<b>SUNDRY NOTICES AND REPORTS ON WELLS</b> (DO NOT USE THIS FORM FOR PROPOSALS TO DRILL OR TO DEEPEN OR PLUG BACK TO A DIFFERENT RESERVOIR. USE "APPLICATION FOR PERMIT" (FORM C-101) FOR SUCH PROPOSALS.)		WELL API NO. 30-015-43096

2. Name of Operator Marathon Oil Permian LLC.		6. State Oil & Gas Lease No.
3. Address of Operator 5555 San Felipe St, Houston, TX 77056		7. Lease Name or Unit Agreement Name Black River 15 State SWD

Well Name: BLACK RIVER 15 STATE SWD 1

## Wellbore Schematic

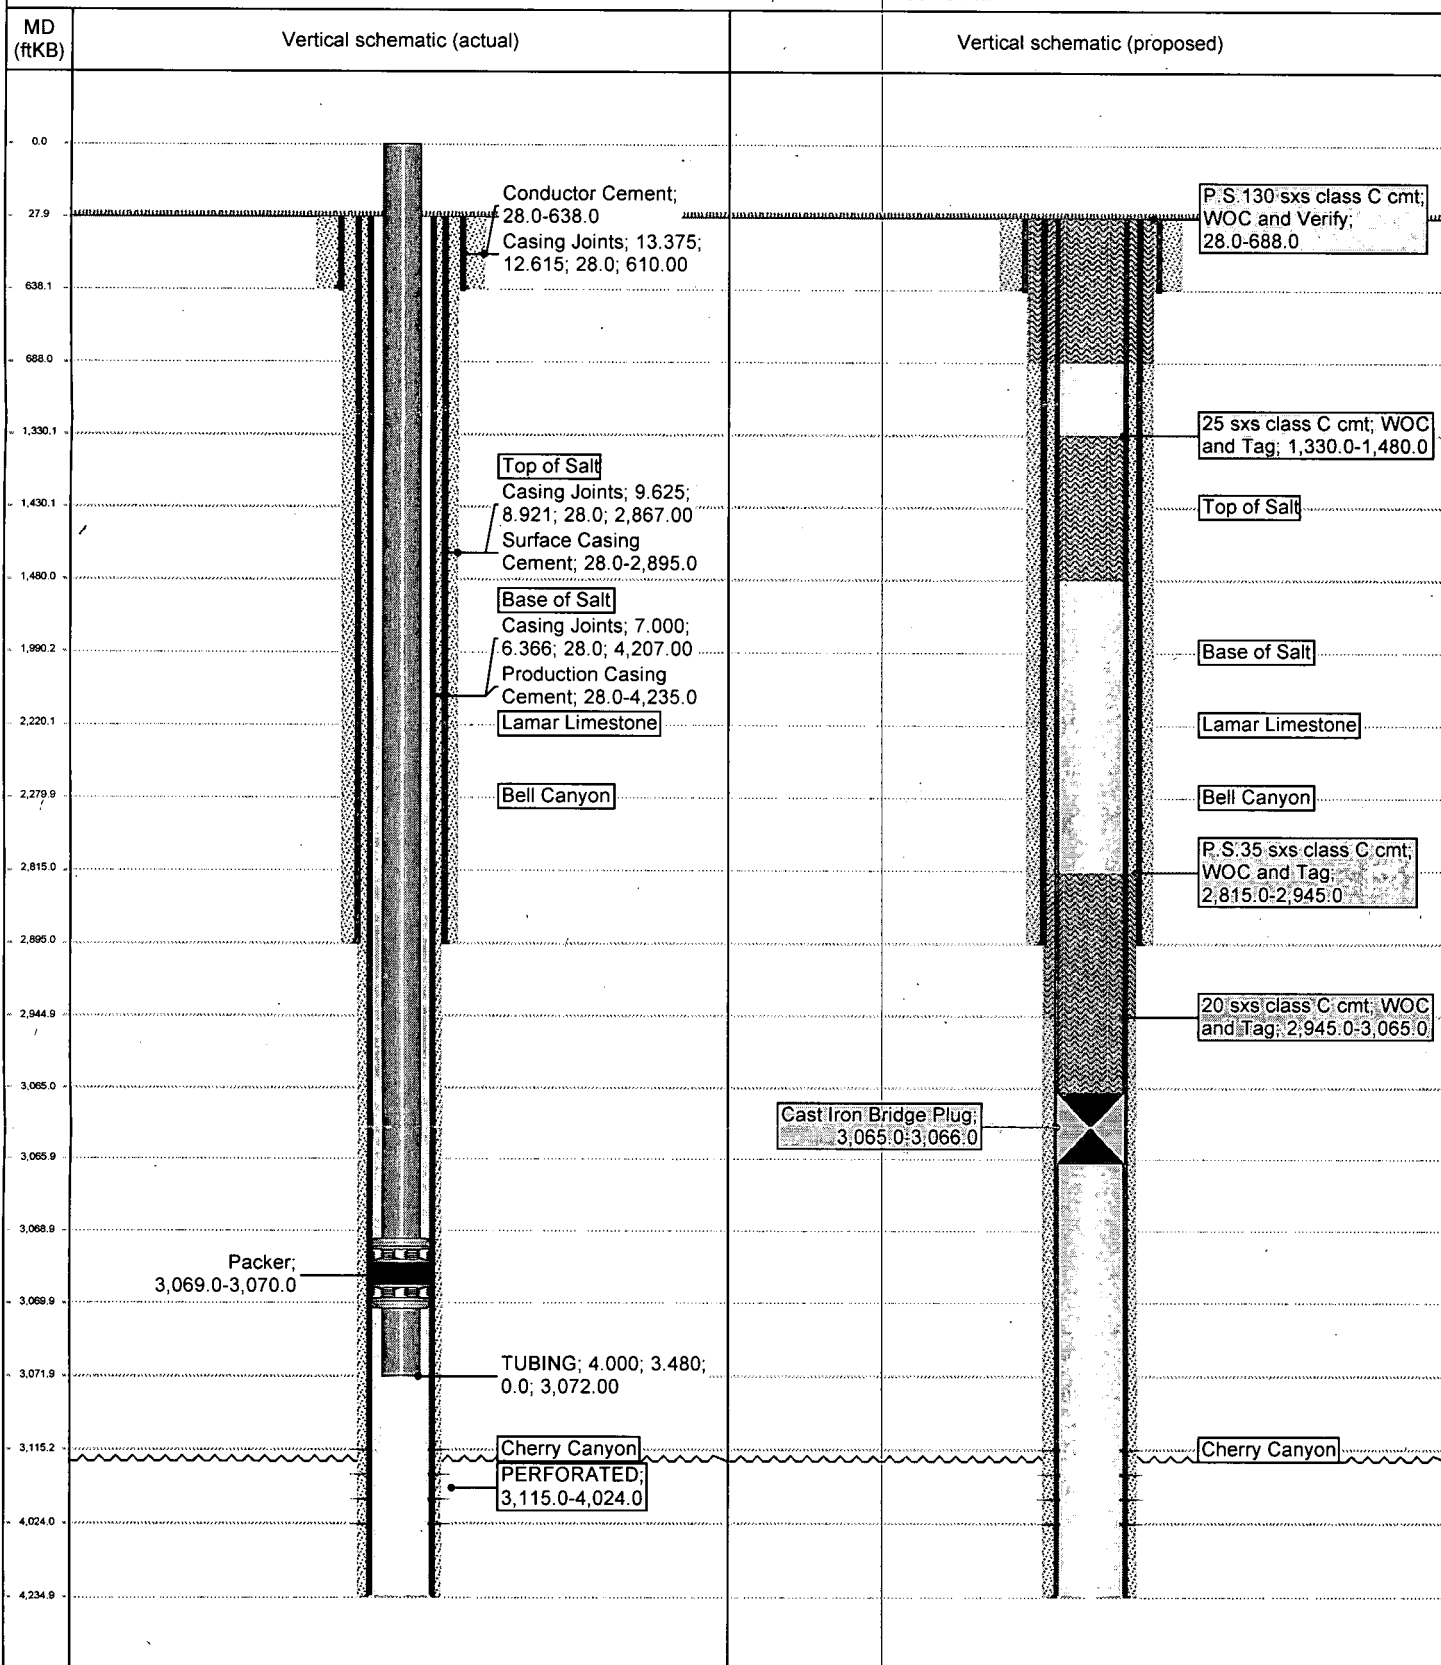
- 1) Set CIPB @ 3,065'  
 2) Spot 20sxs Class C CMT 2,945' - 3,065'; WOC and Tag Same  
 3) P.S. 35sxs Class C CMT 2,815' - 2,945'; WOC and Tag Same  
 3) Spot 25sxs Class C CMT 1,330' - 1,480'; WOC and Tag Same  
 4) P.S. 130sxs Class C CMT 688' - Surface; WOC and Verify Same  
 5) Install Dry Hole Marker

MLF between all plugs

\*\*\* SEE ATTACHED COA'S - Revised
